Addendum A
to the Final Environmental Impact Statement
for the

**POWER SUPPLY UPGRADE – ALGOOD 161-KV
TRANSMISSION LINE**
Putnam County, Tennessee

Responses to Comments Received
on the
Draft Environmental Assessment

TENNESSEE VALLEY AUTHORITY

Figure 1

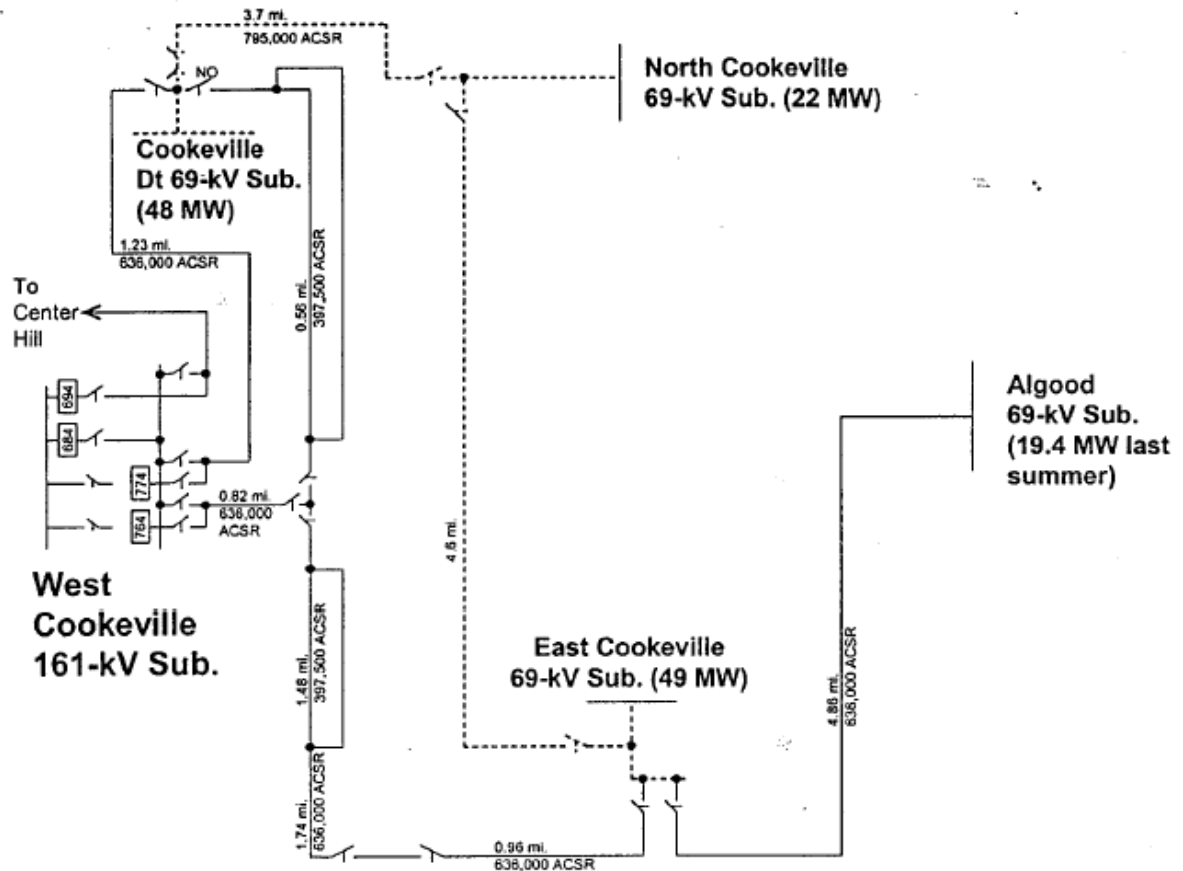
Figure 1 below depicts the critical transmission level facilities with respect to the need for a new Algood substation

- a. The West Cookeville 161-69 kV substation supplies two 69 kV circuits: the first which supplies Cookeville District (“Dt” in Figure 1 stands for “District”) substation and North Cookeville substation, and the second which supplies East Cookeville substation and Algood substation. West Cookeville has 161 – 69 kV transformer capacity of about 153 MVA. Its 2006 peak load was about 144 MVA and, according to a recent letter from TVA, its 2007 peak load was 150.4 MVA. The Cookeville Electric Department (“CED”) receives supply from the West Cookeville substation which is owned by TVA, while Upper Cumberland Electric Membership Cooperative (“Upper Cumberland”) also contracts for capacity from West Cookeville substation. Upper Cumberland owns and operates the Algood substation.
